UNITED STATES PATENT AND TRADEMARK OFFICE

APPLICATION NO.	FILING DATE	FIRST NAMED INVENTOR	ATTORNEY DOCKET NO.	CONFIRMATION NO.
10/708,521	03/09/2004	Joseph E. Broyles	R254	2520
22692 7590 04/03/2007 REGINALD F ROBERTS JR 1422 HEARTHSTONE DRIVE BATON ROUGE, LA 70808-1161			EXAMINER SAN MIGUEL, ANITZA M	
			ART UNIT	PAPER NUMBER
			3733	
SHORTENED STATUTORY PERIOD OF RESPONSE		MAIL DATE	DELIVERY MODE	
3 MONTHS		04/03/2007	PAPER

Office Action Summary

DETAILED ACTION***Drawings***

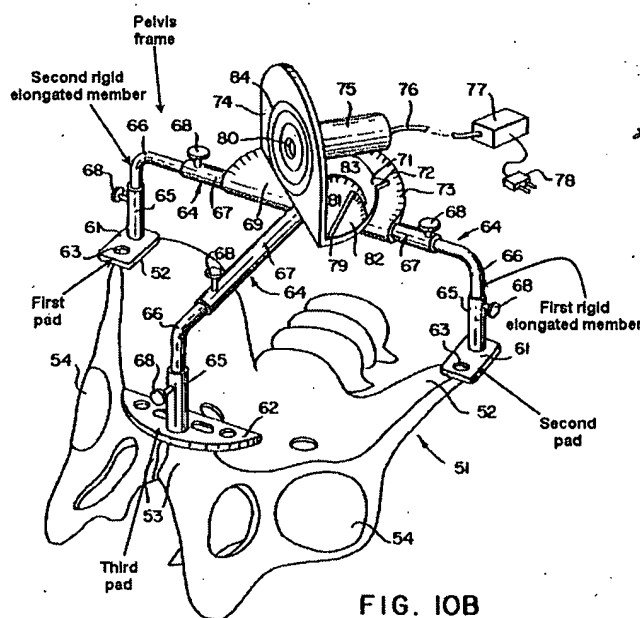
Farmer et al. discloses a pelvis frame comprising: a first rigid elongated member (see Figure 10B below); a second rigid elongated member mounted on the first rigid

elongated member in a perpendicular relationship thereto (see Figure 10B below); first and second pads attached to the first rigid elongated member in a perpendicular configuration (see Figure 10B below); a third pad attached to the second elongated member in a perpendicular configuration (see Figure 10B below); and means for varying position of the first, second, and third pads, and for fixating said position as required, for effecting orientation-determining contact of the first, second, and third pads with pelvic bone of the patient; the first, second, and third pads being contoured to conform to portions of the pelvic bone which said pads contact (col. 2, lines 4-16; col. 9, lines 14-31). The first and second pads include openings (63) for insertion therethrough of first and second wires used to determine the patient's orientation.
